PEER REVIEW OF ACCIDENT SOURCE TERMS FOR LIGHT-WATER NUCLEAR POWER PLANTS USING HIGH-BURNUP AND MIXED OXIDE FUEL

PEER REVIEW OF ACCIDENT SOURCE TERMS FOR
LIGHT-WATER NUCLEAR POWER PLANTS USING
HIGH-BURNUP AND MIXED OXIDE FUEL

December 2011

**Work Performed Under the Auspices of
United States Nuclear Regulatory Commission
Washington, D.C.
Contract Number NRC-HQ-11-F-04-0001**

Cumulative Iodine Releases to Containment During the In-vessel Release Phase

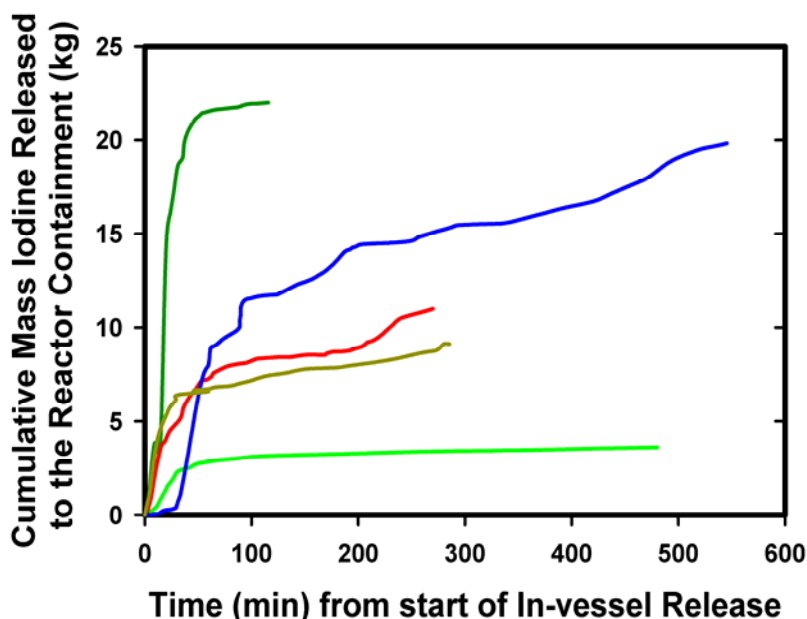
Evaluation

No decision has been made to divide in-vessel release into two stages. Expert opinions on the wisdom of retaining the assumption of a single phase with a constant release rate are solicited. At this juncture, it appears that in-vessel release could be divided into two phases each with a different but still constant release rate. No decision has been made to develop this alternative. Calculations to assess the impact of such a division of the in-vessel release phase on consequences would be a considerable expansion of the scope of this work and might take some time to accomplish. A crucial issue that will arise in dividing in-vessel release into two stages will be the criterion for ending the first and starting the second phase. Quite a range of behaviors was observed in calculations (See following slide showing single and multiple plateau and varying rates of initial and later release.) A clear-cut phenomenological basis for division of in-vessel release into two stages has not been identified. Consequently, whatever is selected will be viewed, in all likelihood, as arbitrary by some. Experts may want to offer their suggestions on a criterion if they feel it essential to segment in-vessel release into two phases.

Figure B.3.1 Measured FP gas release to the gap and plena of fuel rods

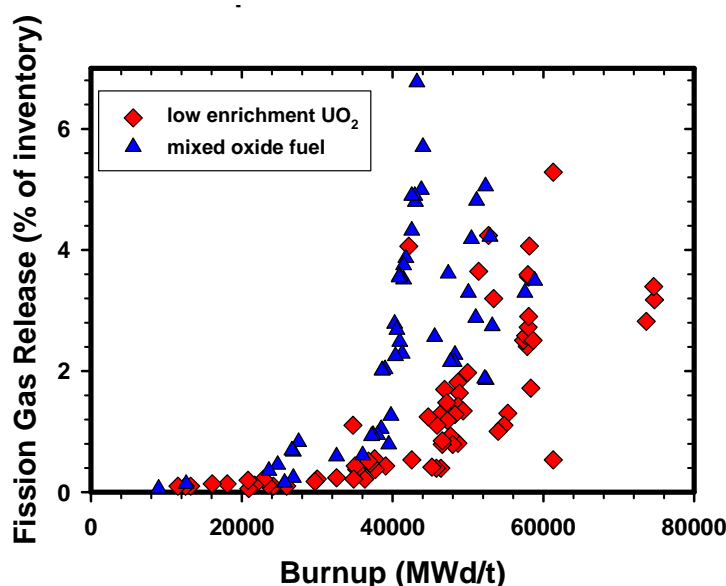
Interesting. It would be useful to obtain data for the puncture tests. We have access to data for PWR fuel shown in Figure B.3.1. It appears that variability in the gap inventory depends on both burnup and linear power rate. For the work under review, we attempted to control both at prototypic levels. It is also noteworthy that BWRs are going to fuel rods similar to those of PWRs as burnups are taken to higher levels. Currently, 10 x 10 BWR fuel assemblies are being used and there appears to be efforts to go to 14 x 14 arrays.

The given explanation for the gap release is quite logical. However, I am slightly concerned that the end of present gap phase or the initiation of in-vessel release is determined at the time of increase in release up to 5%. Since the present phase name, "gap release", is closely related to the phenomenon, some people easily imagine that the FP release due to the cladding burst is equal to 5%.

Figure B.3.2 Distribution of concentration in grain and pores in pellet at elevated pressure [1]

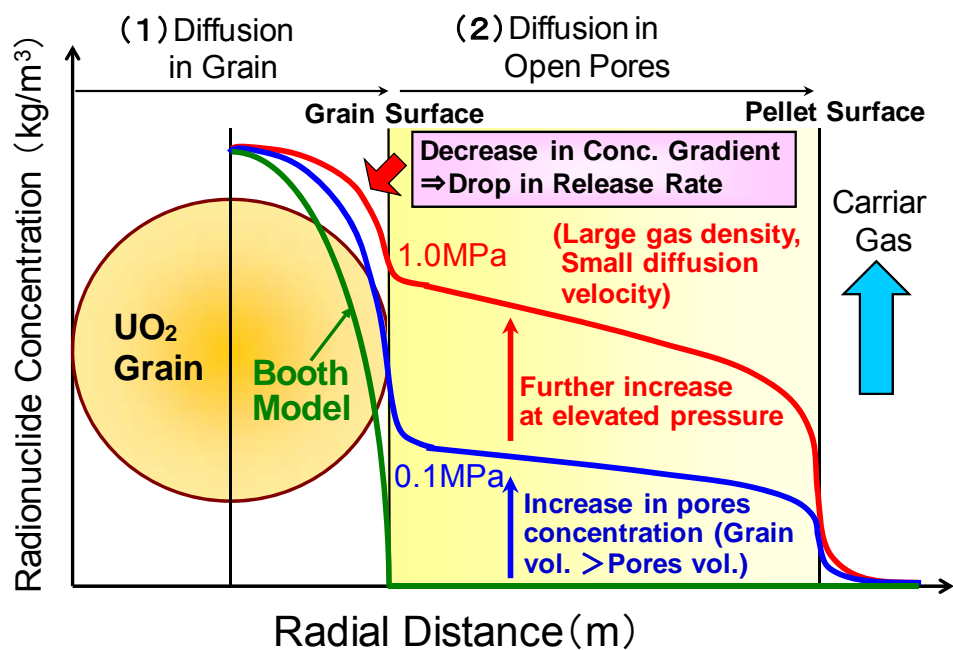
I consider that the pressure effect does not only depend on the Knudsen diffusion but also on increase in the concentration gradient in the grain. That is, the rate-determining step exists at both of diffusion in grain and pores. Expected distribution of radionuclide concentration in UO_2 grain and open pores in pellet at elevated pressure are shown in Figure B.3.2.

Figure B.3.3 Comparison of Cs release between measurements and $1/P^{0.5}$ CORSOR-M model [1]

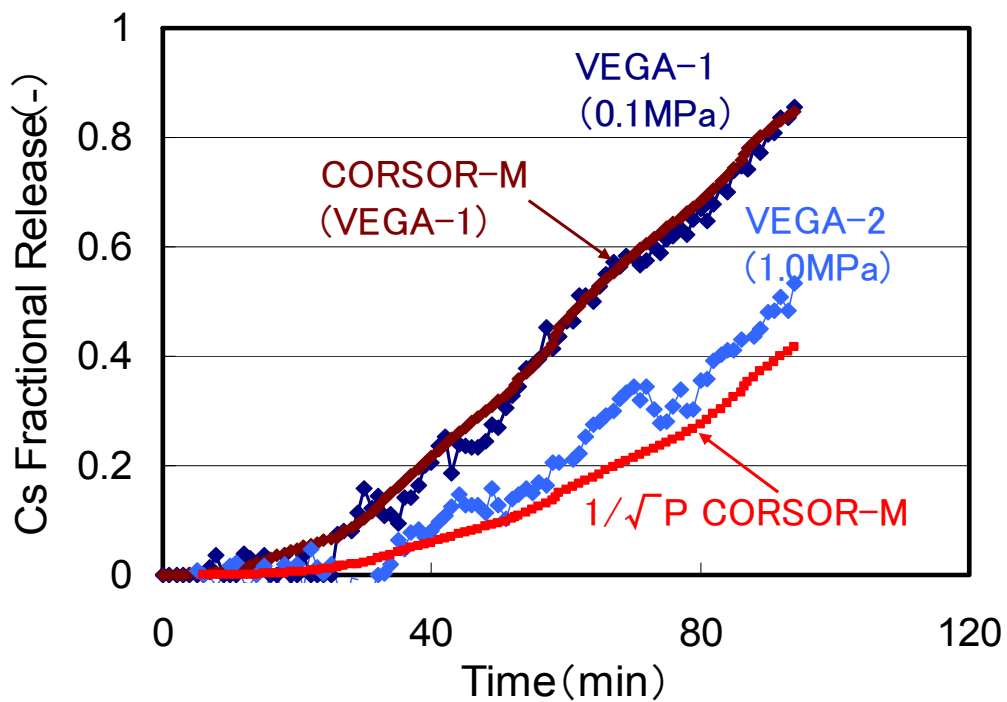
The elevated pressure could cause increase in gas density in open pores and decrease in gaseous diffusion velocity. These result in increase in radionuclide concentration in small-volume pores and at grain surface although the diffusion velocity in grain is much slower than that in open pores. The concentration increase at grain surface may suppress radionuclide release from grain because it decreases the concentration gradient in grain that is a driving force of diffusion. Consequently, the pressure dependence will not vary from the reciprocal of pressure to the reciprocal of the square root of pressure but vary from the reciprocal of smaller pressure dependence, for example, the cubic or fourth root of pressure, to the reciprocal of the square root of pressure. In reality, the pressure dependence with the reciprocal of the square root of pressure will slightly overestimate the observed pressure effect as shown in Figure B.3.3.

Figure B.3.4 Mo-O phase boundaries projected on the phase boundaries for U-O

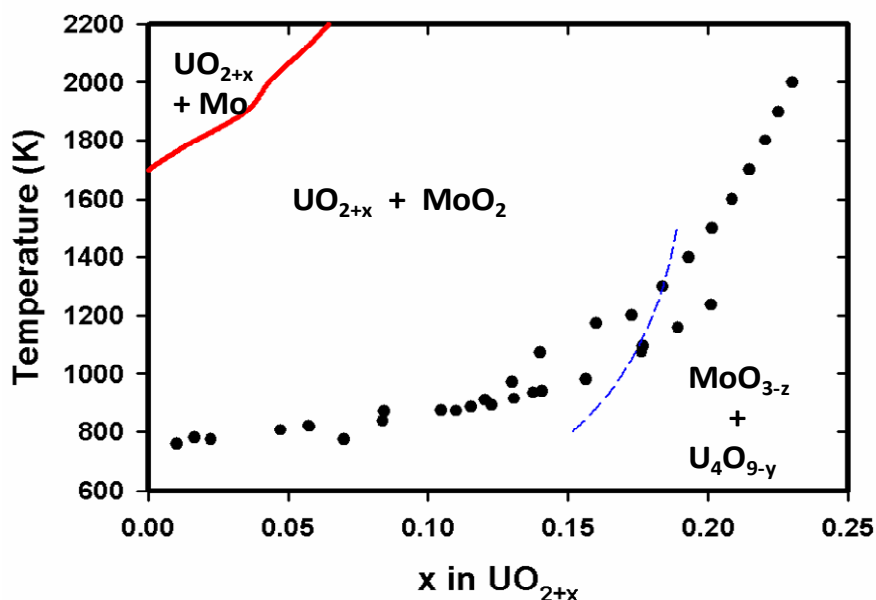
We have not been able to find experimental confirmation of the theoretical hypothesis that oxygen potential in irradiated MOX will be significantly higher than irradiated LEU. We believe that oxygen potentials in both fuels once they become hyperstoichiometric is buffered by the equilibrium:

where Mo is alloyed in nodules with Ru, Pd, Rh and other elements (see Figure B.3.4). The molybdenum dioxide product may or may not be soluble in the fuel lattice to an appreciable extent. The equilibrium is essentially the same for both types of fuel and so the oxygen potentials are about the same. Certainly, they are sufficiently similar that we are unable to find data that would provoke major changes in the modeling. It is hoped that further insights will be derived from the forthcoming VERDON experiments. We fully anticipate that results of these tests along with results from the VEGA tests will provoke improvements in the state of the art and, consequently, in the MELCOR modeling.

Figure B.3.5 Ellingham diagram of relevant elements [2]

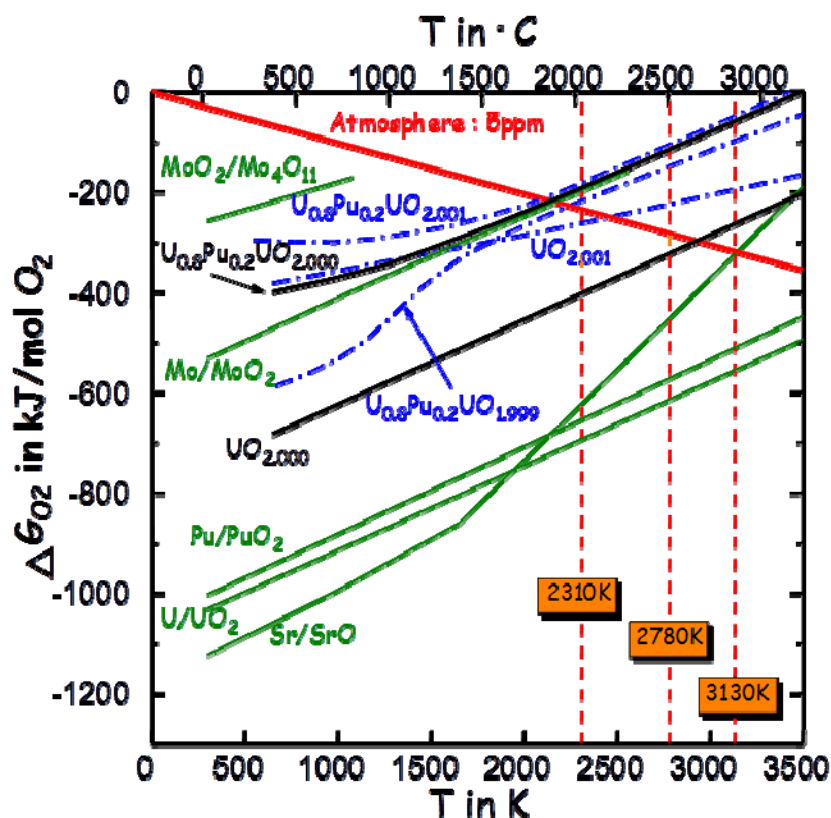
“As the technical basis for the higher oxidation potential in MOX fuel ($U_{0.8}Pu_{0.2}UO_{2.000}$) than that in UO_2 fuel, Figure B.3.5 [2] prepared by H. Kleykamp was referred in the VEGA test interpretation. In fact, the comparison between VEGA-M1 and VEGA-8 showed that the Ru release from MOX fuel became higher than that from UO_2 fuel.”

After that, I continued the discussion with several specialists and tried to find the experimental data which directly shows the higher oxidation potential in MOX fuel than that in UO_2 fuel. A lot of specialists agree with the idea that the oxygen potential in MOX could be larger due to the formation of precious metals but we could not find any data at all except for the release data in VEGA tests which support the higher oxidation potential in MOX fuel. Although I agree with the SNL's response that explains the buffering of stoichiometry by Molybdenum oxidation, further examination is considered to be needed for the oxidation potential of MOX and UO_2 fuels. Concerning the VEGA results, it is necessary that the reproducibility of the results be further examined.

Figure B.3.6 Comparison of radionuclide release between VEGA-M1 and ORNL-Booth [3]

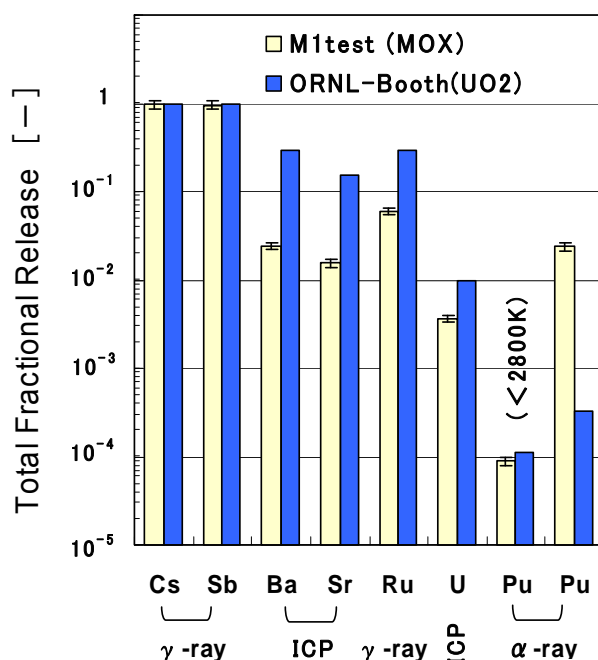
The release of Pu from MOX below 2,800K was predicted well by the conventional models such as ORNL-Booth while the release above 2,800K was enhanced and became larger by about one order of magnitude than that of the conventional models[3]. The existing models including the ORNL-Booth model underestimated it by about two orders of magnitude due to lack of experimental data at such high temperature as shown in Figure B.3.6. The enhancement of Pu release above 2800K was also observed in the VEGA-8 test with UO_2 fuel (see Table B.3.1).

However, it should be pointed out that the eutectic reaction could proceed too much in the VEGA geometry with crucible that maintains liquefied materials compared with the reality without crucible. The eutectic reaction is expected to be further examined in other future tests that simulate better the actual conditions during severe accidents.

Figure C.1 Release rate coefficients U and Pu in VEGA-M1 and VEGA-8 tests

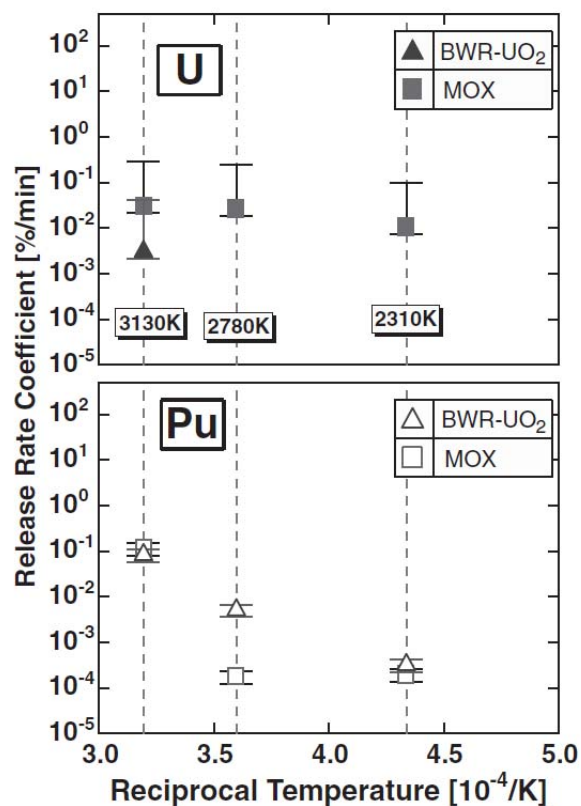
I looked at the experimental database to determine whether there was evidence that the values predicted by MELCOR might be too low. There are some measured releases of cerium or plutonium in the various small scale experiments that yield fairly large releases under reducing conditions. The strongest evidence is probably in the VEGA experiments as described by Dr. Hidaka. In Figure C.1 (Figure 9 from the VEGA report), the release rates measure at 2128K (melting point of Zr; lower bound on fuel melting) is 1E-4 %/min and at 2800K (50-50 ZrO₂/UO₂ eutectic temperature, which was the fuel collapse temperature used in MELCOR calculations) is 1E-3 %/min. At either of these rates, it would take less than a minute to exceed 1E-7 release fraction. I realize that these tests are always distorted in some respect and a direct comparison is questionable but it is evidence of a potentially larger release mechanism than modeled in MELCOR. From NUREG/CR–6261, an ORNL summary of release experiments, in the VI series releases from fuel were observed as shown in Table C.2.2. Of these the VI-5 release is the most surprising. Nevertheless, the other releases shown are also substantially larger than 1E-7.
